L2 Update

IEEE 802.3at Task Force

Anoop Vetteth

Proposed New Mirroring Scheme

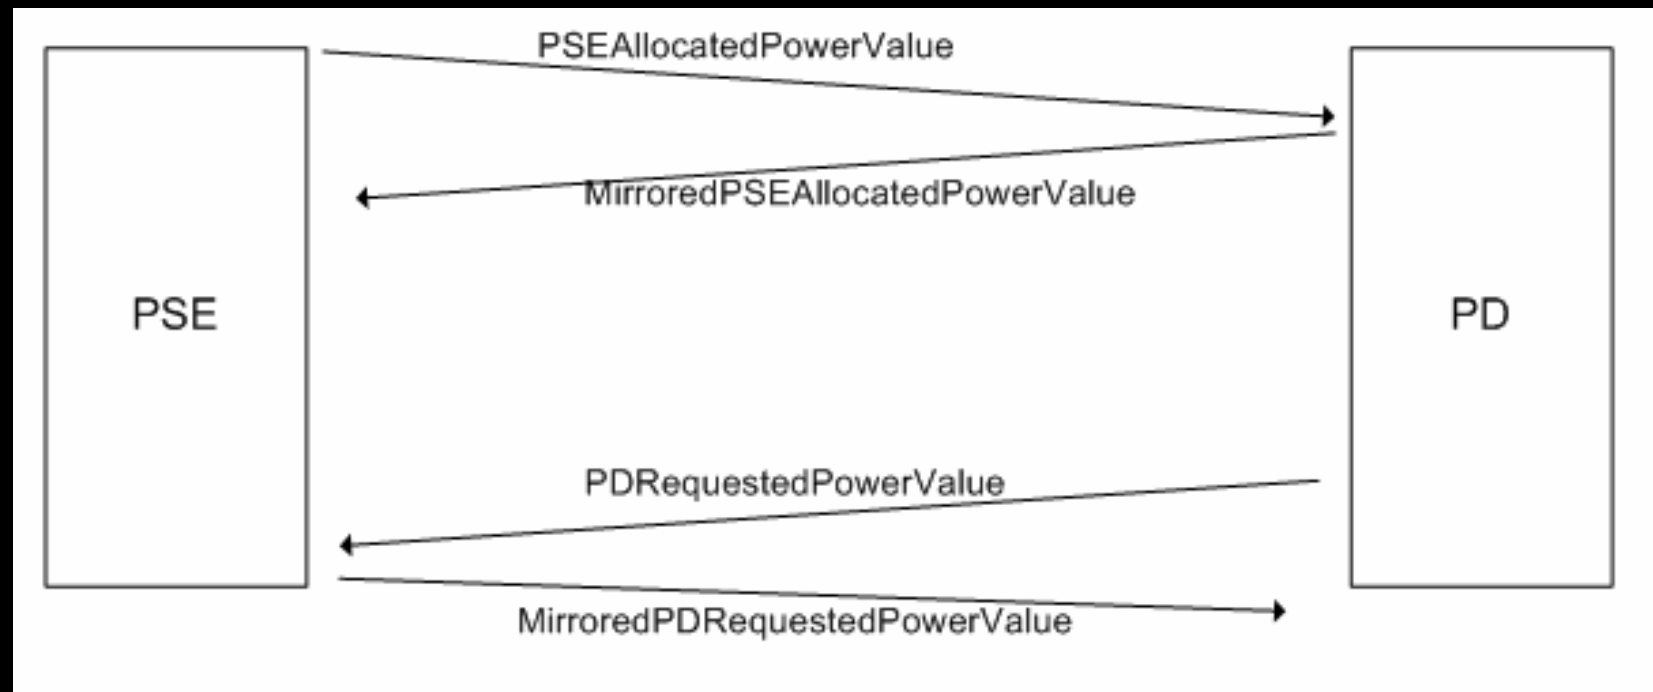
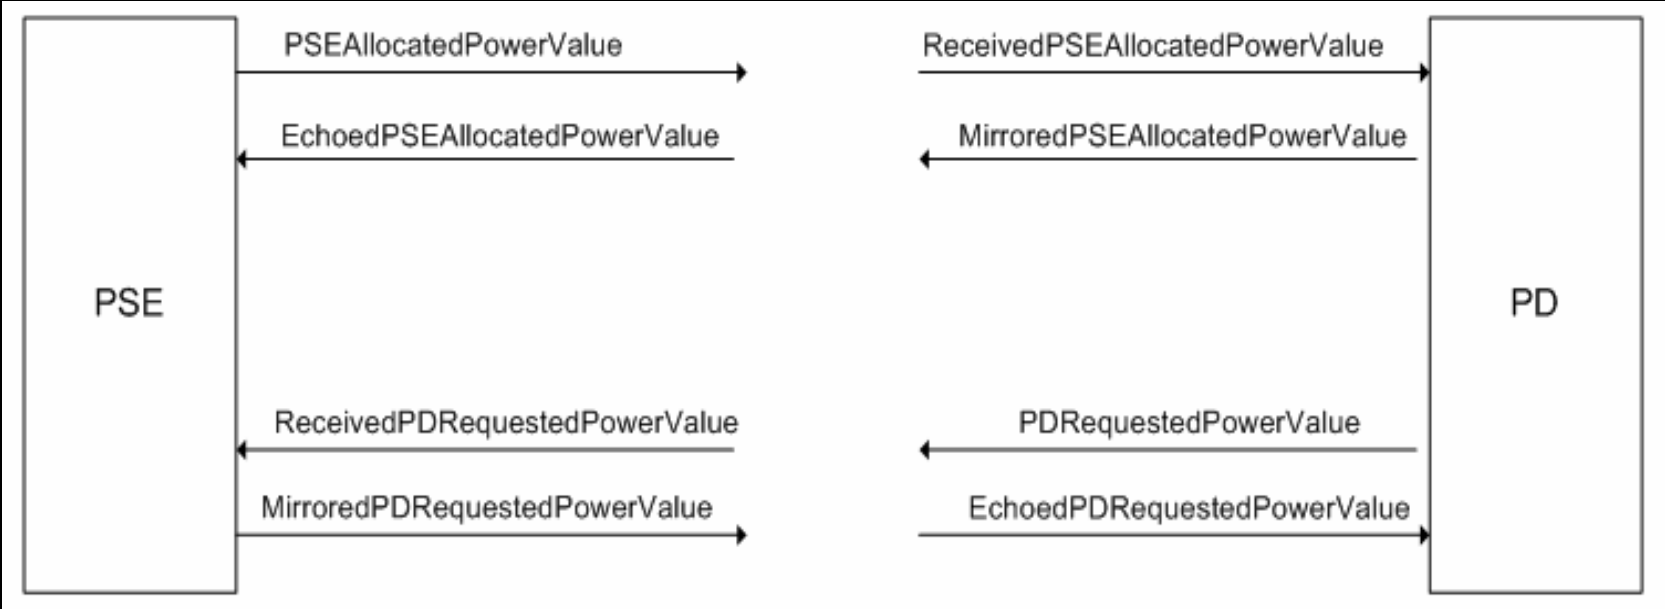
Present Mirroring Scheme

- The Mirrored value is the received value corresponding to which the power review is conducted
- If a PSE receives a PDU where the echoed value does not match the Allocated Power Value, it ignores the PDU
- If a PD receives a PDU where the echoed value does not match the Requested Power Value, it continues to treat the PDU as valid
